INTERNAL MEMORANDUM

Application No: 19/P/0835/OUT

Location: Bleadon Quarry, Bridge Road, Bleadon, Weston-super-Mare BS24 0AU

Formal comments from Highways & Transport Development Management

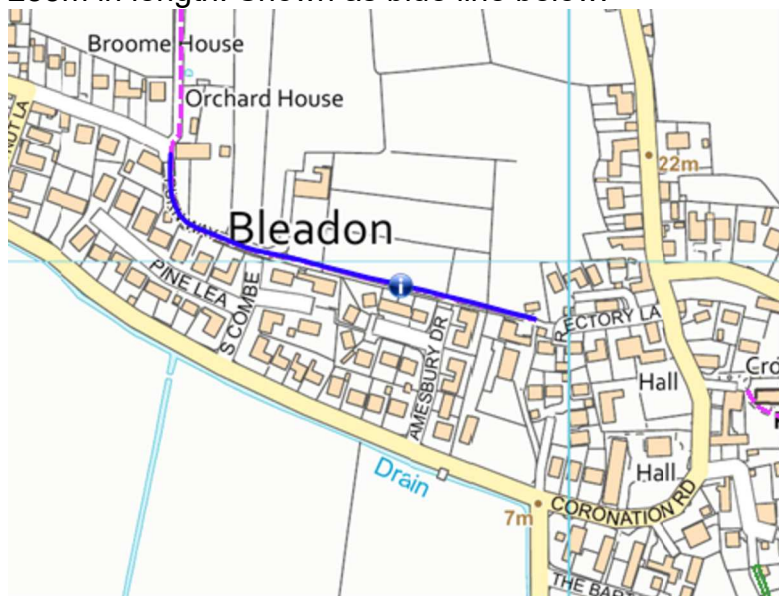
An officer from the Home to School team of the Integrated Transport Unit has now walked the public footpath route from the proposed pedestrian access at Old School/Mulberry Lane to Purn Lane, where footways are present for onward routes to Oldmixon Primary School and Broadoak Academy secondary School. This route is within the allowed walking distance of 2 miles for primary pupils and 3 miles for secondary pupils and is considered to be a safe route to school.

Whilst the route is considered safe, some upgrading of the footpaths is required to ensure they are suitable for everyday use for walking to school. The route is shown on the map below.

Instead of a contribution for the cost of home to school transport for primary and secondary pupils for a period of 10 years, we require the applicant to deliver upgrades to the footpaths by Section 278 condition. **Please condition.**

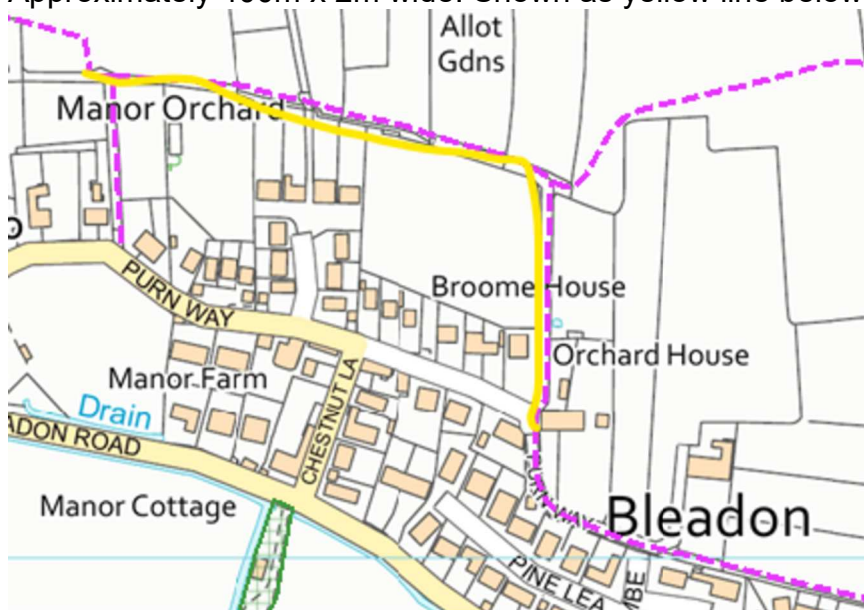
Footpath ref. AX6/12/10, re surface the existing width of the footpath with tarmac. Approximately 285m in length. Shown as blue line below.

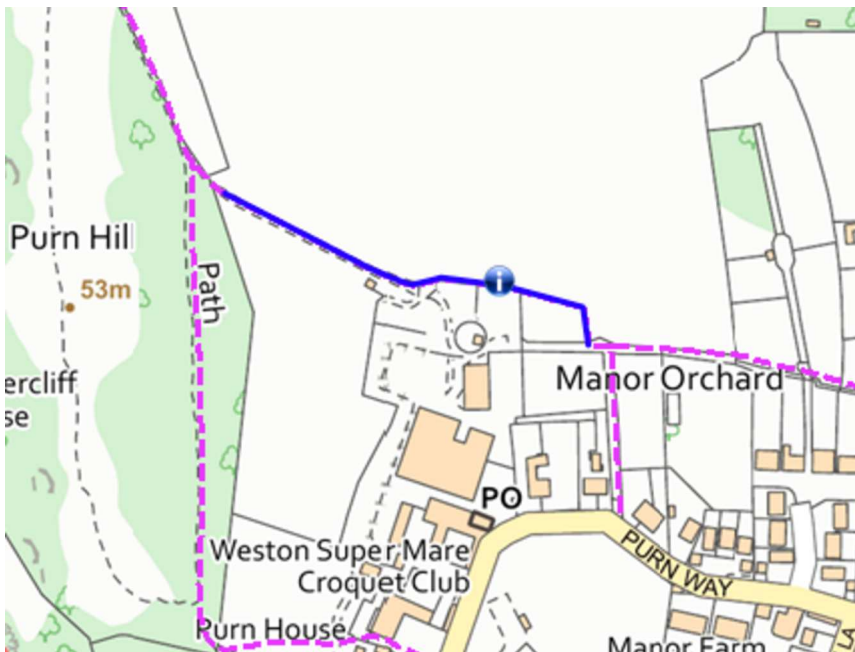
AX6/11/10 & AX6/10/20 resurface footpath to 2m wide with Tarmac Ultritec or equivalent. Approximately 400m x 2m wide. Shown as yellow line below.
